DHC-8 (DASH 8)

SERVICE BULLETIN 84-32-143

Landing Gear – MLG Solenoid Sequence Valve Latch And Retract Software Logic Changes – ModSum 4-126659

This page transmits Revision 'B' of Service Bulletin 84-32-143, pages 1 thru 14, dated 16 Nov 2016.

**PSEU Removal / Installation
Figure 1**

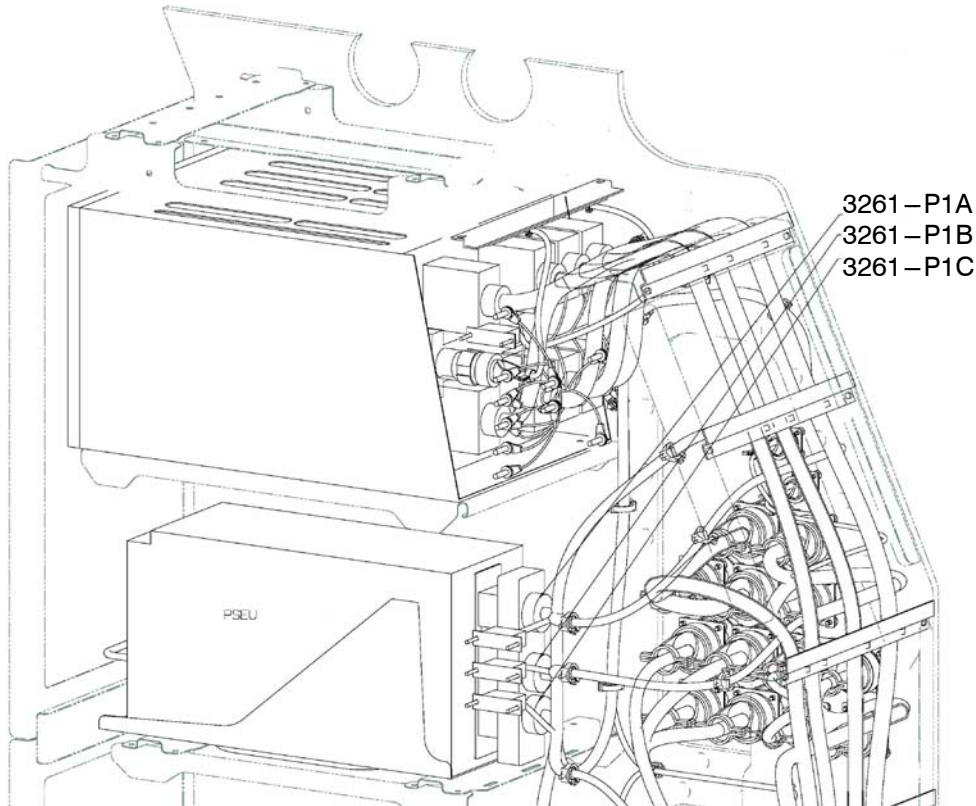
- (1) Locate the existing PSEU P/N 30145-0201/-0301/-0401 or -0501 (refer to Figure 1).
- (2) Remove the existing PSEU P/N 30145-0201/-0301/-0401 or -0501 (refer to PSM 1-84-2 (AMM) TASK 32-61-01-000-801).
- (3) Rework the polarization keying of existing PSEU connector 3261-P1A/B/C as follows:
 - (a) Gain access to the front of PSEU connector 3261-P1A/B/C on the mounting tray (refer to Figure 2 VIEW A for connector location).

**PSEU Connector 3261-P1A/B/C Location - Rework
Figure 2**

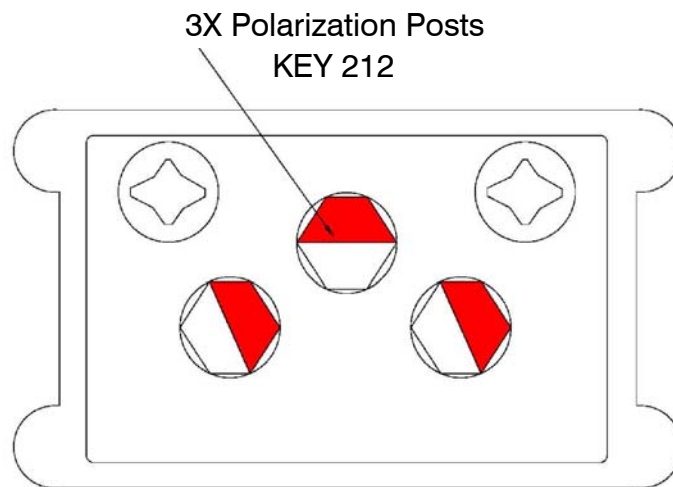
- (b) Change the existing polarization posts positions as shown in Figure 2 VIEW B to agree with applicable instructions given in PSM 1-84-2W Wiring Diagram Manual (WDM) Chapter 20-17-51-401.
 - (c) Reidentify reworked connector as 8MK4787-001 to agree with applicable instructions given in AMM TASK 20-00-01-910-802.
- (4) Adjust the following proximity sensors to the new gaps given below as follows:
